## OFFICER DECISION IN CONSULTATION WITH CABINET MEMBER

### LONG NEWTON – TRAFFIC CALMING

## TRAFFIC CALMING, LONG NEWTON

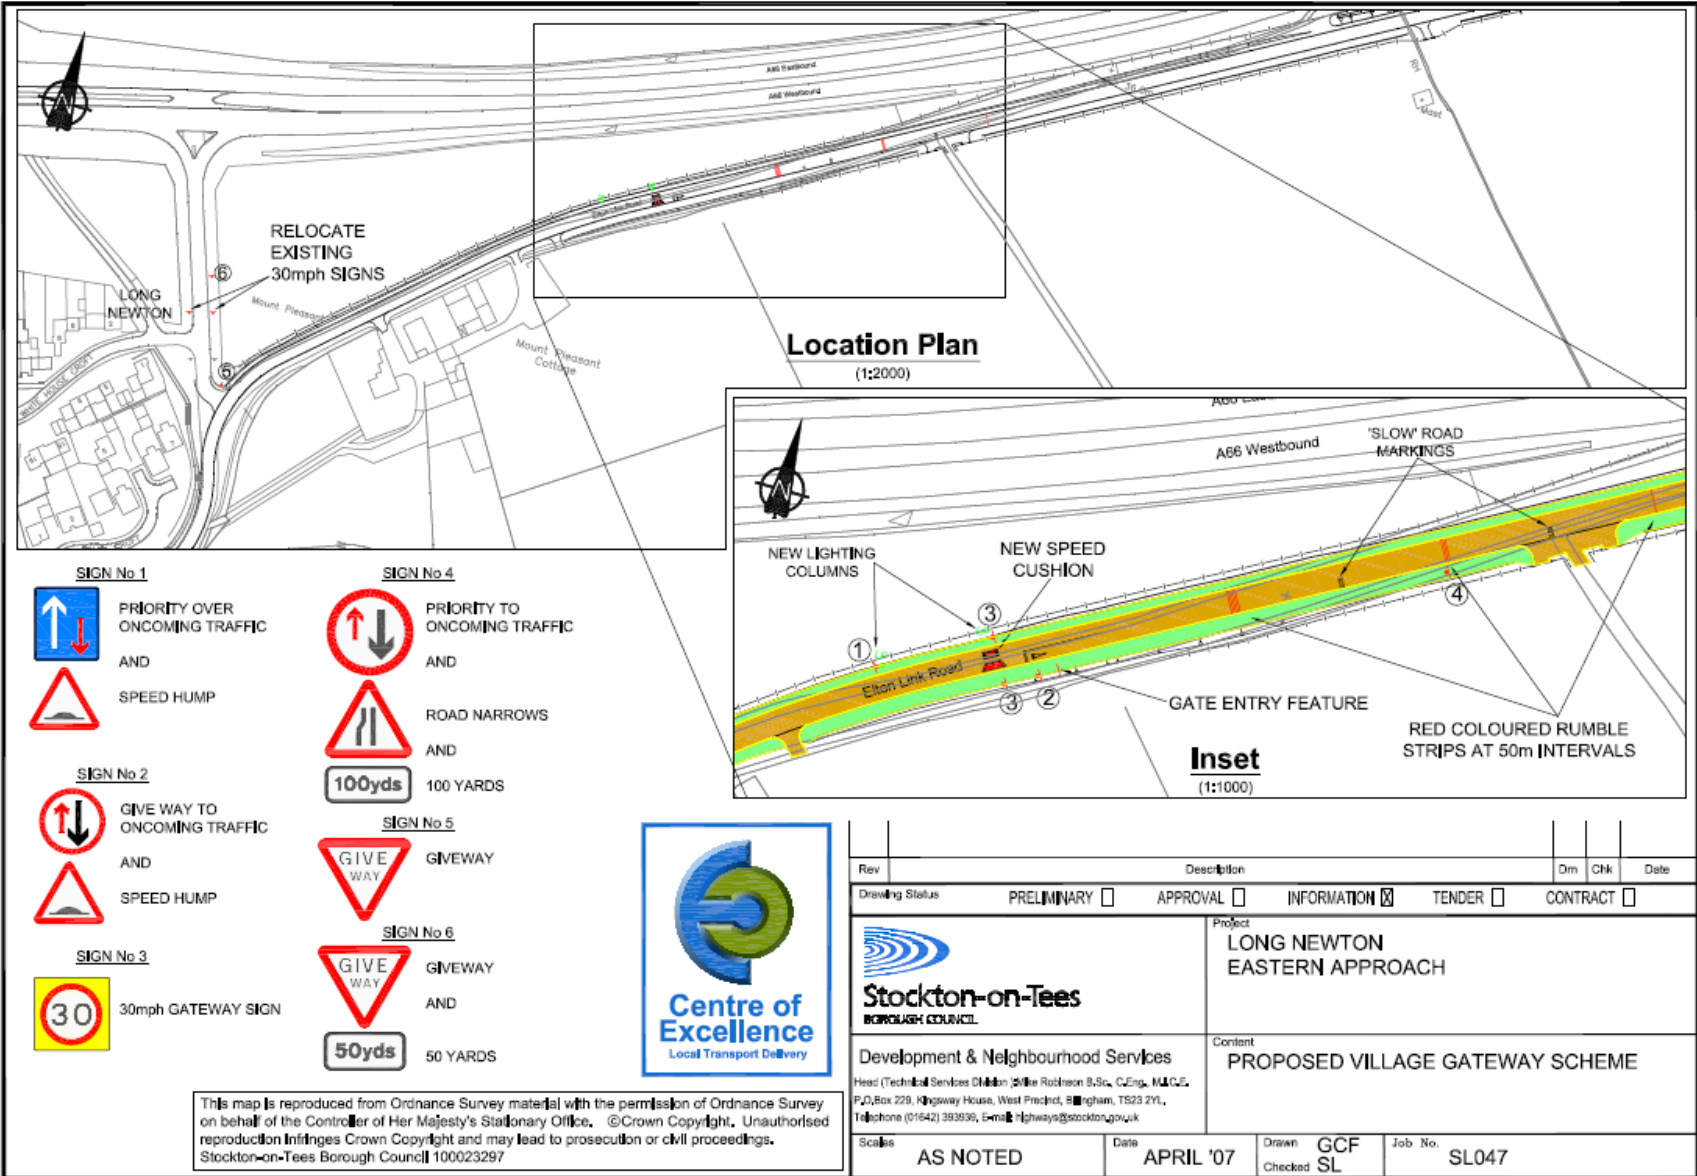
5	x	Re Plan SL048: Gateway signs and 30mph signs are too near the Willow Chase and will impair sight lines when leaving willow chase. 30 signs should be closer to roundabout with later warning system. Is red speeding flush or raised. Re Plan SL047: Disagree with rumble strips, they are not effective and have been found to generate more problems than they solve. Have been removed in other areas of Redcar and Cleveland. Speed humps are ineffective, road narrowing system without humps is better.	The provision of 30mph signs on a 112mm dia pole should not impair visibility. The red coloured rumble strips are thermoplastic the same thickness as normal road markings and should not create too much noise. See comment at 1	
6	<input checked="" type="checkbox"/>	Against traffic calming, speed cushions do not have much effect. Restricted traffic flow is more satisfactory, such a system is in operation in Sedgefield. Residents of Elton are already complaining about speed cushions.	See comment at 1

# Appendix 1

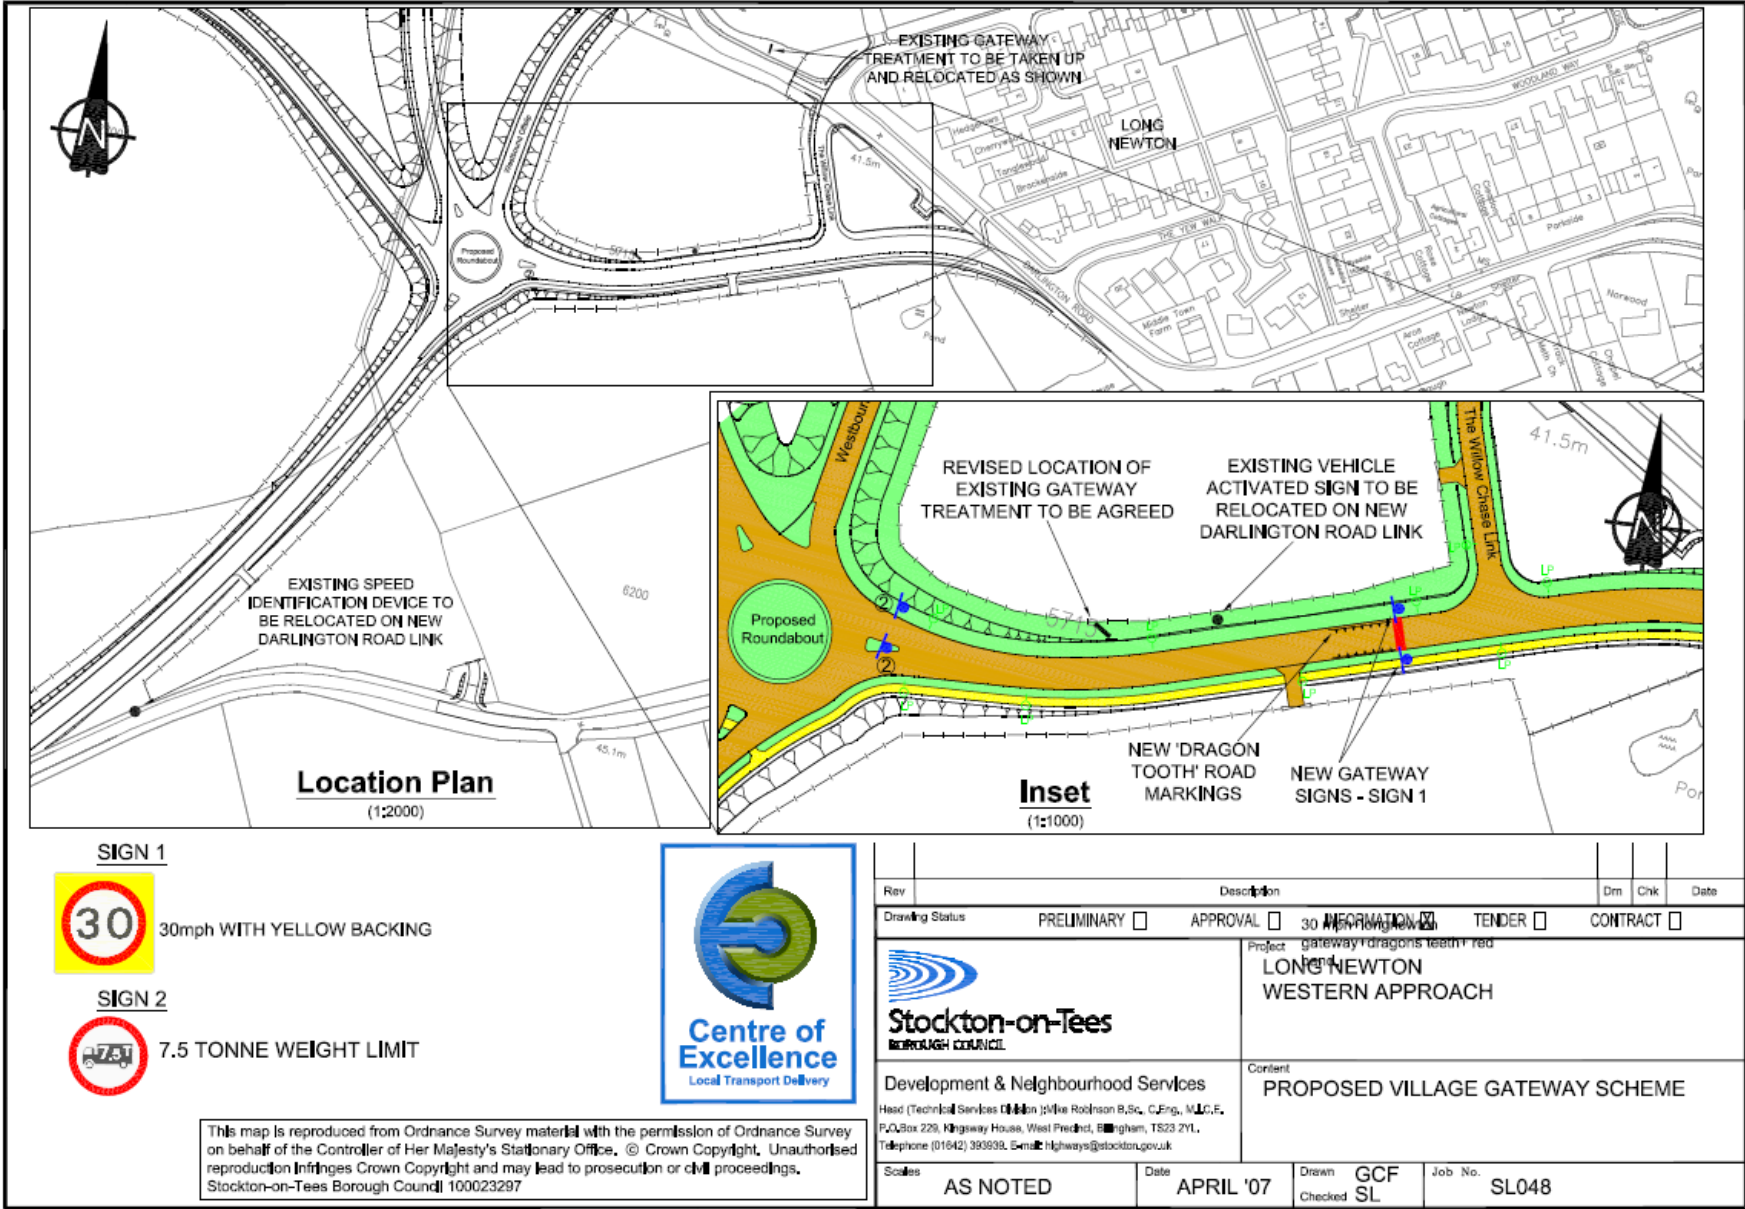
4	<input checked="" type="checkbox"/>		Concerned about the change in priority where Elton Link road joins Darlington Road. If priority remains the same with traffic having to turn right leaving the village, and turn left entering the village this would slow traffic down coming into the village. Without this I fear traffic would speed through the eastern end of the village.	In order to avoid confusion for drivers who do not know the area it is logical to use the arrangement as indicated on the plan
